Product Change Notification

PCN Number:	RLPCN164002
Product Category:	Electromechanical SMT Signal Relays
Subject:	FTR-B3(G;S)xxx FTR-B4G;S)xxx carrying tape material supplier change.
Product series:	FTR-B3, FTR-B4 SMT signal relay series.
Date:	03-Oct. 2016

Nr.: RLPCN164002

Comparison between current and after change A-PET material appearance.

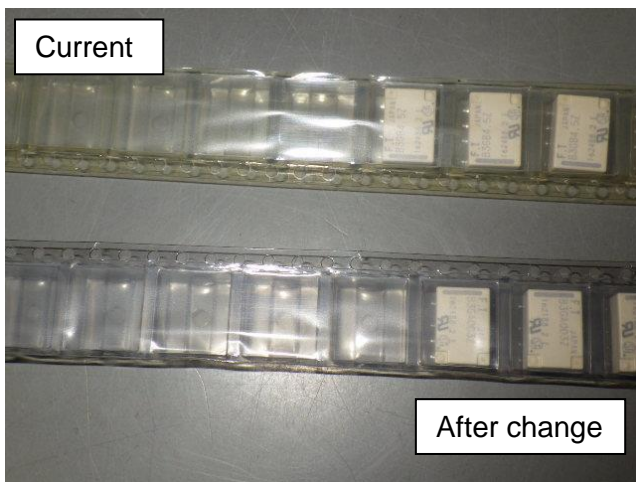
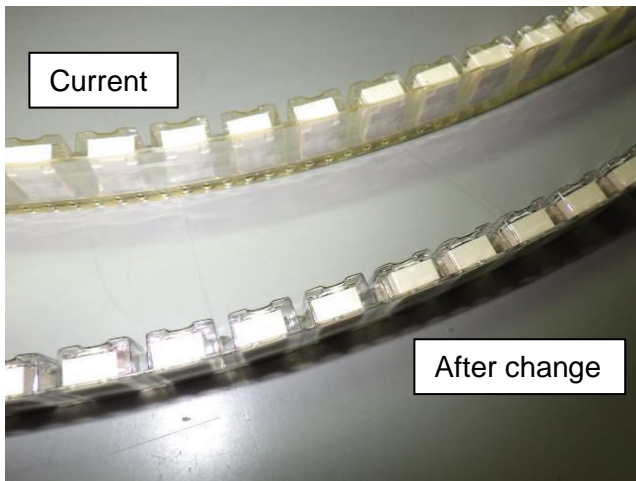
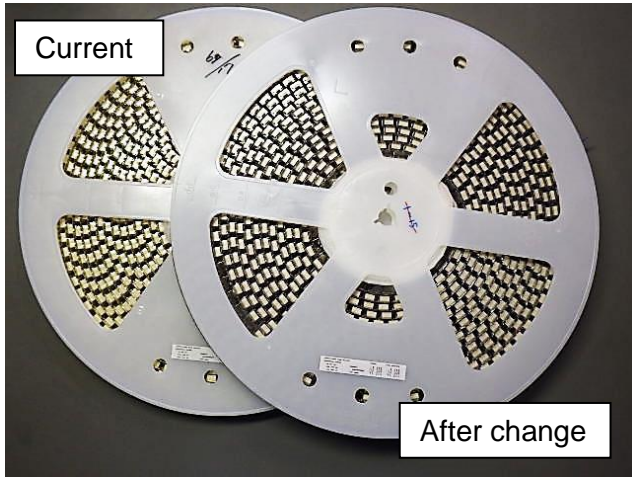
Supplier change for the A-PET embossed carrier tape, used for FTR-B3(G;S)xxx and FTR-B4G;S)xxx SMT relays.

Current	After change
Supplier and part number	Supplier: Toyobo Part number: A560YY2R	Supplier: Maruai Part number: SCS-V
Specific gravity	1.34	1.34
Yield strength [Mpa]	54~64	63.1
Breaking point [MPa]	59~93	75.2

See Supplemental comparison pictures between current and after change embossed carrier tape on page 2.
